Technical Note TN-823

Introduction of the T2000-A46 Enhanced Signalling Interface for the T203X/40

5th March 2004

220-01344-05 to 220-01344-12

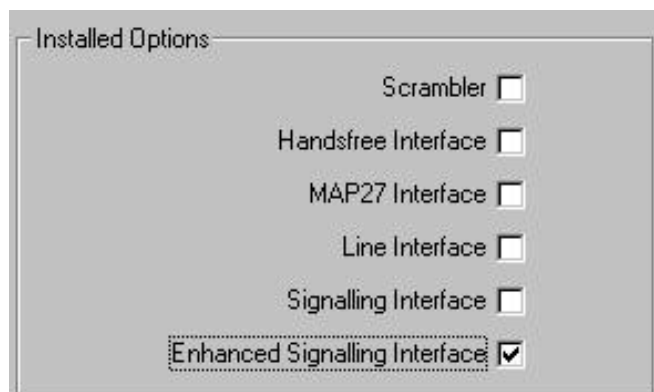
Logic boards with the IPN 220-01344-05 to –12 will need to be modified as follows...

- A link must be fitted between TP602 and pin 17 of #T3K44 (refer to photo below).

- Remove the chip capacitor C516 (0603 100N). This is located near RV507.

The modifications described above **cannot** be made to Logic boards with IPNs of **220-01344-04 or earlier**.

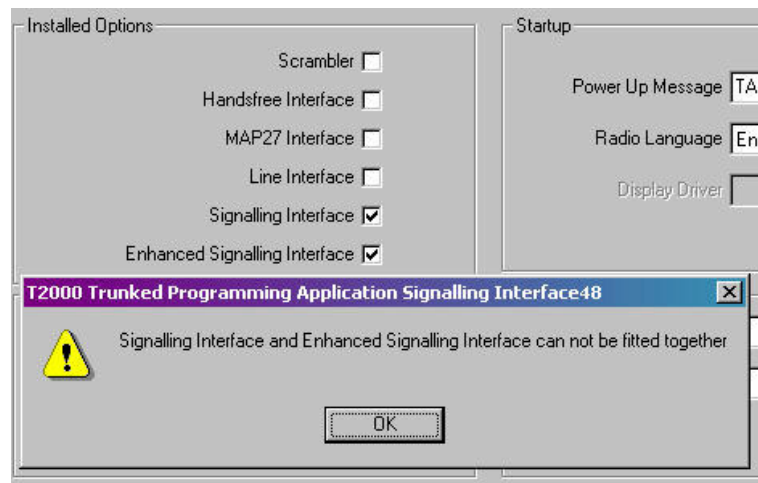
There are two changes to the Trunked Programming Application (TPA). The first is the addition of a field with a tickbox called "Enhanced Signalling Interface" on the *Specifications* page.

The field "Signalling Interface" will still remain so users of the T2000-A4500 can still program their radios. These two fields are mutually exclusive.
